City of Puyallu Development Engineering APPROVED

- A. STREET ADDRESS 300 RIVER ROAD, PUTALLUP, WA 98371
- B. PARCEL NUMBER(S) 0420214010, 0420214027 & 0420281154
- C. PROPERTY AREA 3.054 ACRES

- A. APPLICABLE CODE 2018 INTERNATIONAL BUILDING CODE 2018 WA STATE ENERGY CODE AS APPLICABLE TO THE PROPOSED ADDITION
- B USE **AUTOMOTIVE SALES & SERVICE**
- C. CONSTRUCTION TYPE TYPE V-B, NON-SEPARATED USES

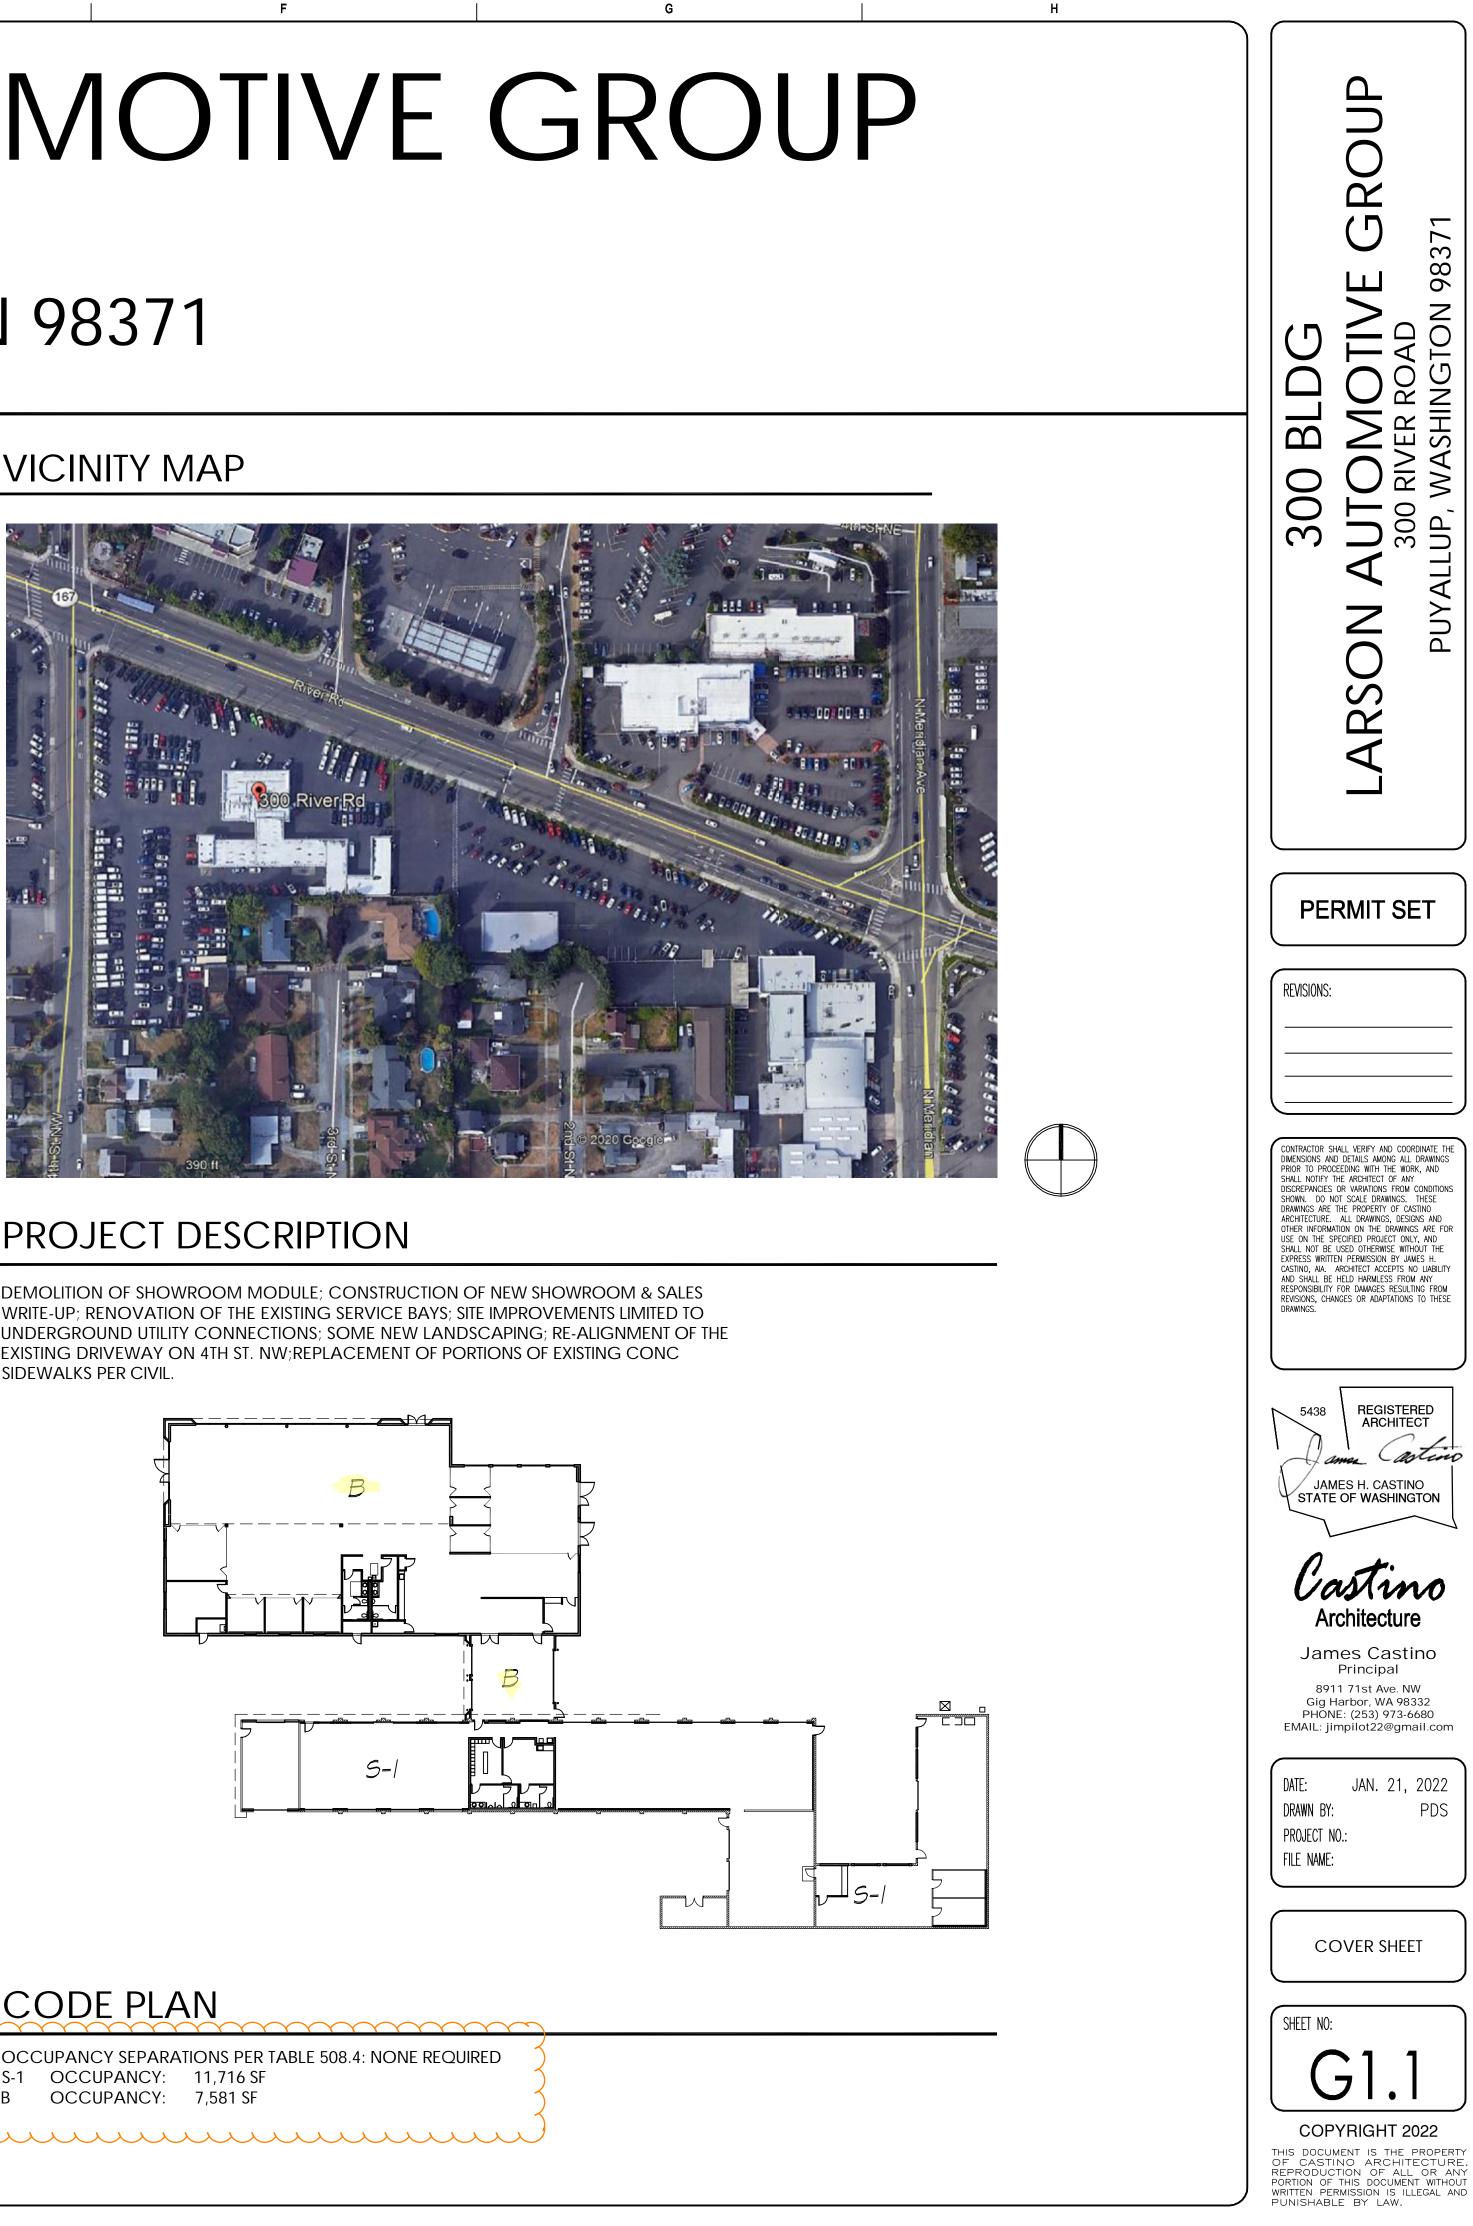
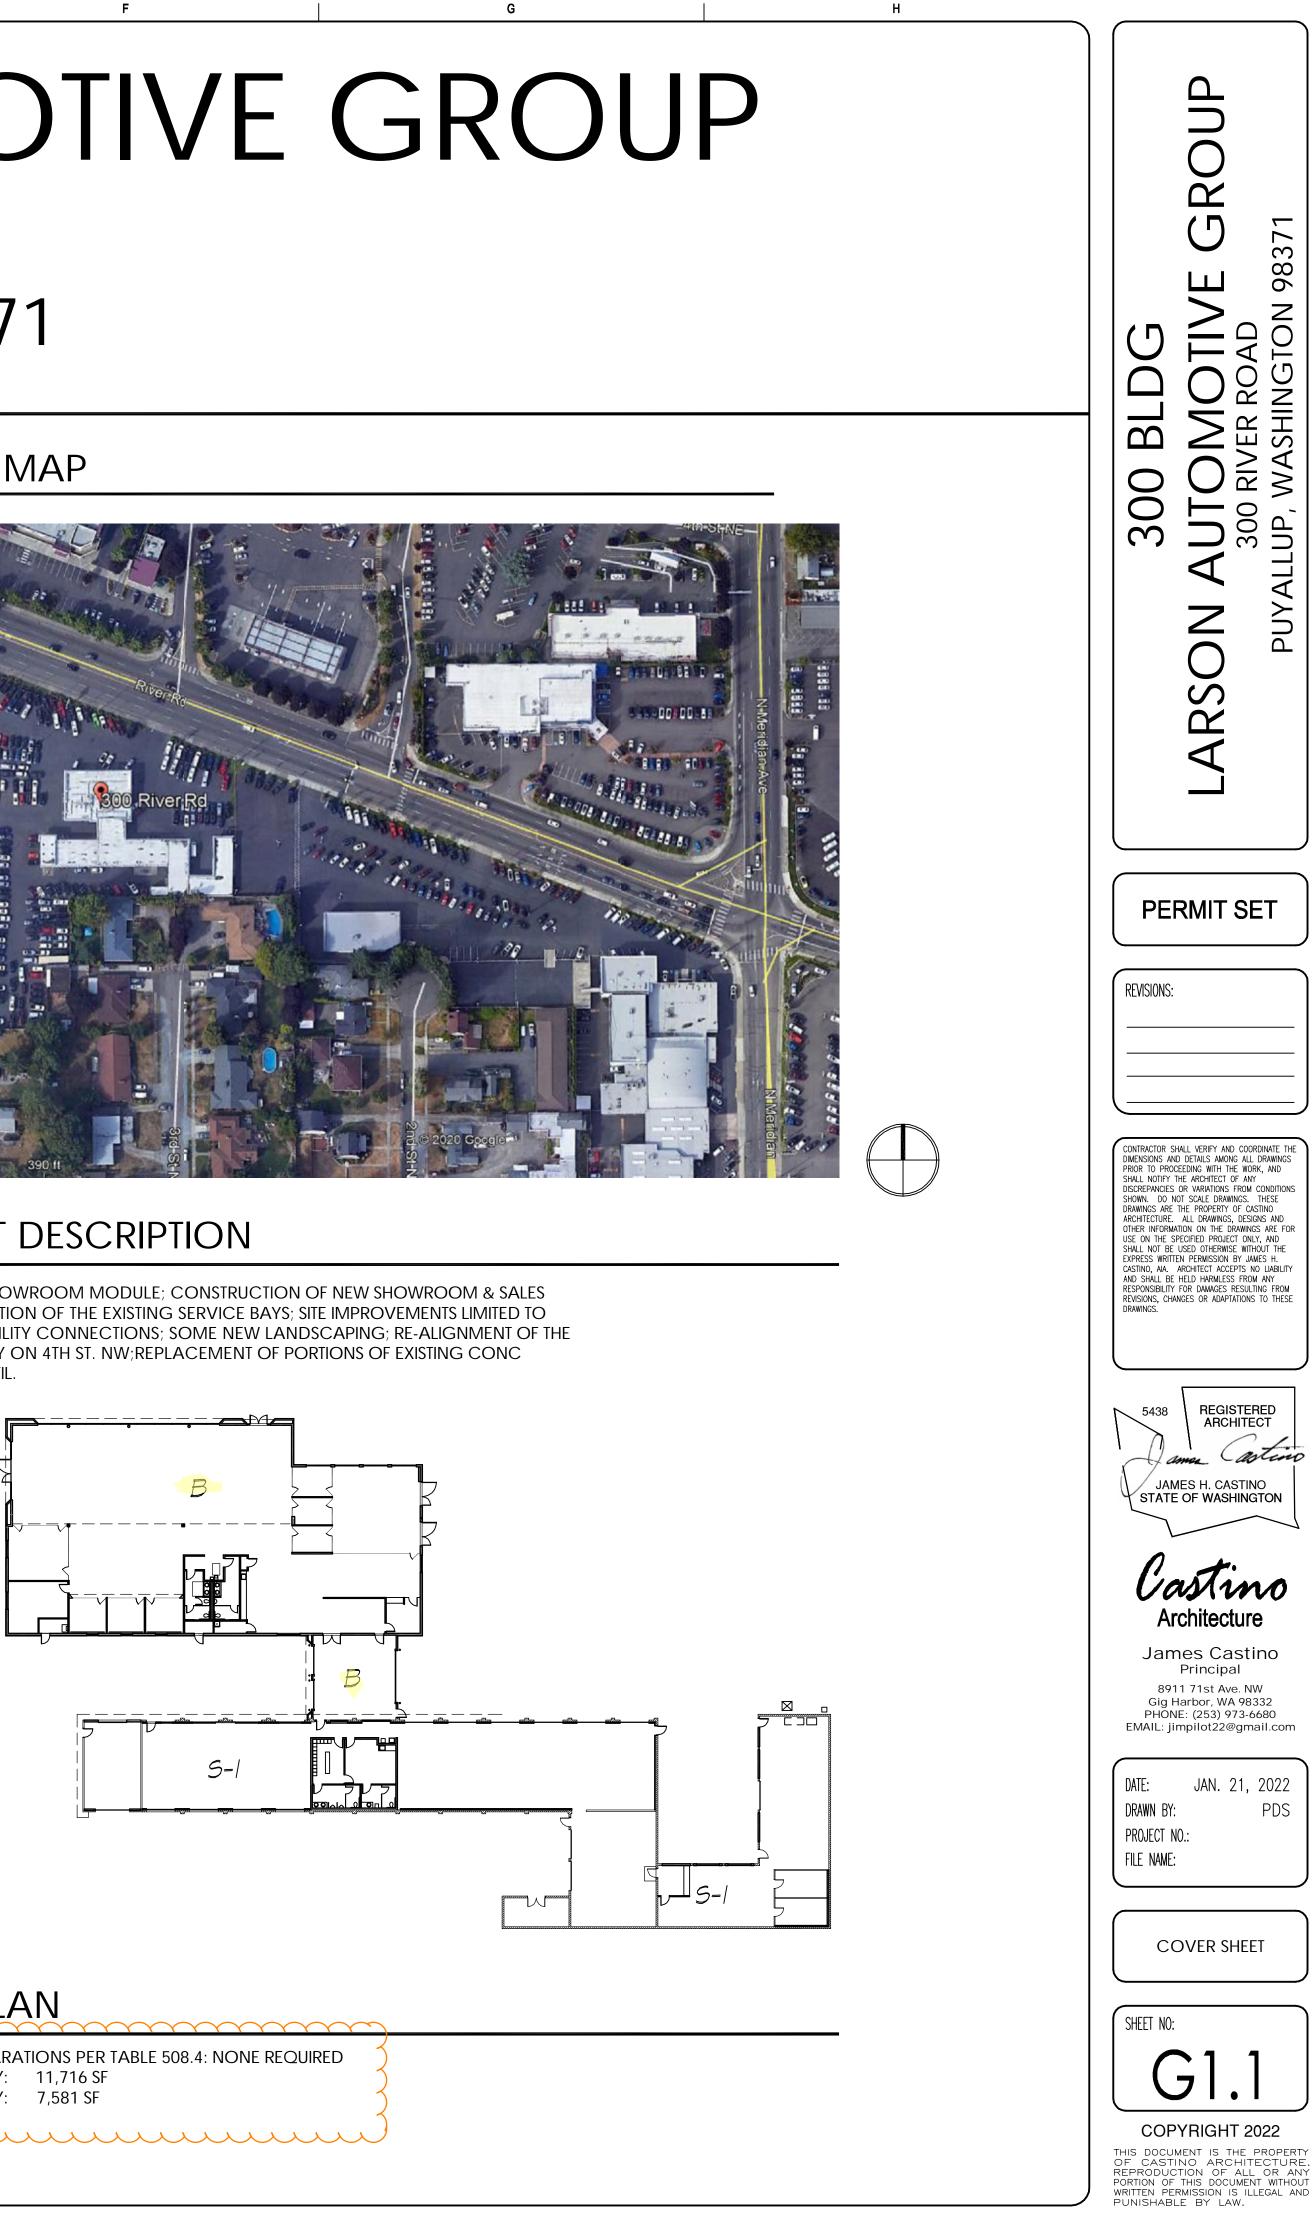
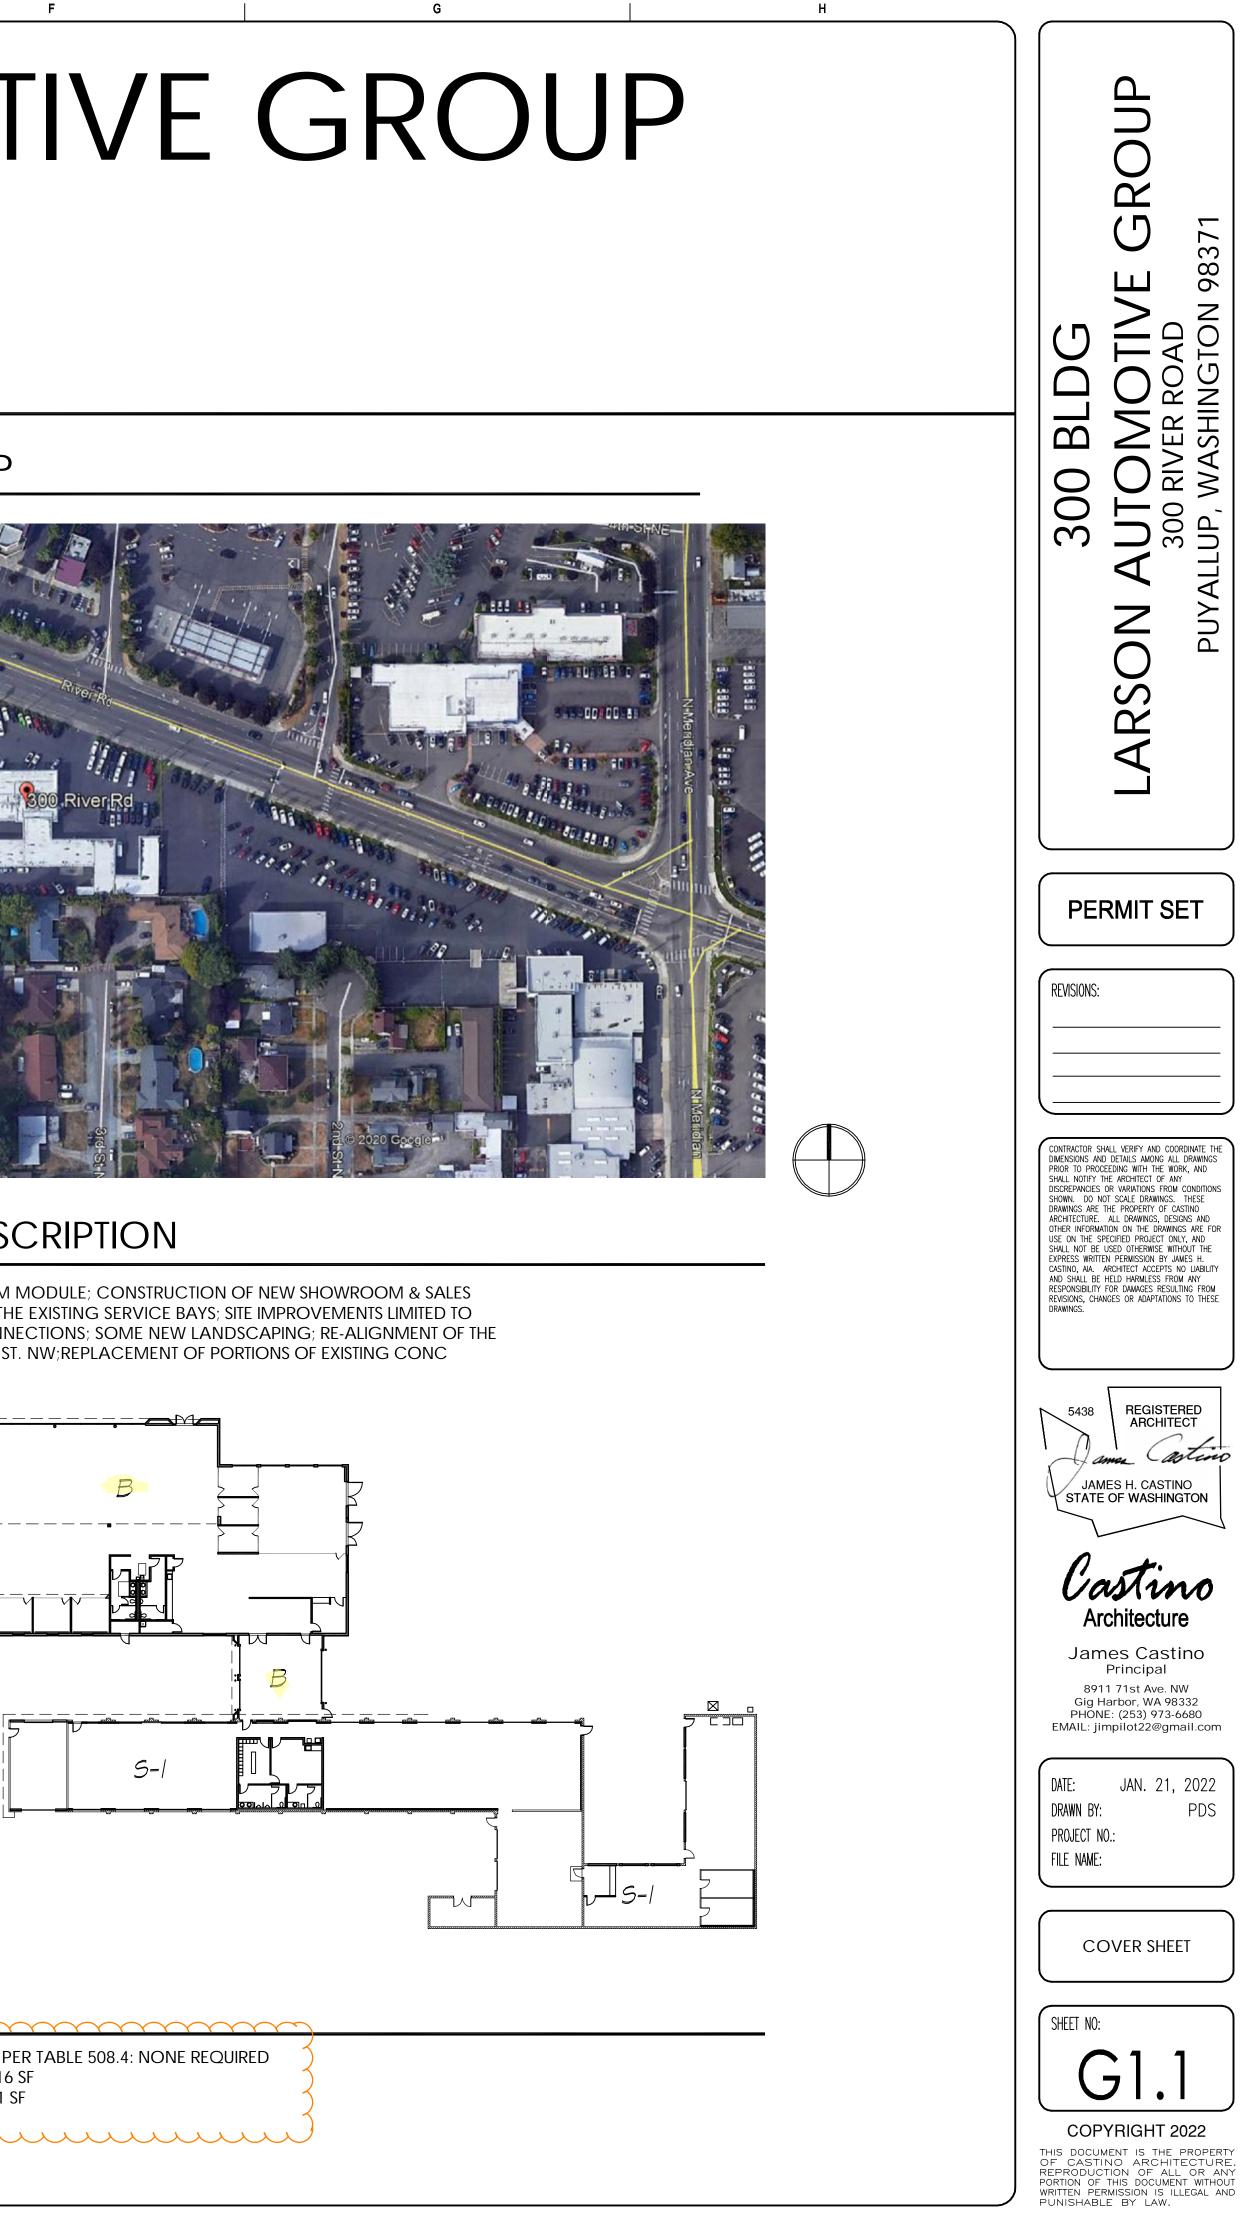
G1.1 - CODE PLAN NOTES B OCCUPANCY TYPE M,

REVISE TO CORRECT OCCUPANCY TYPE.
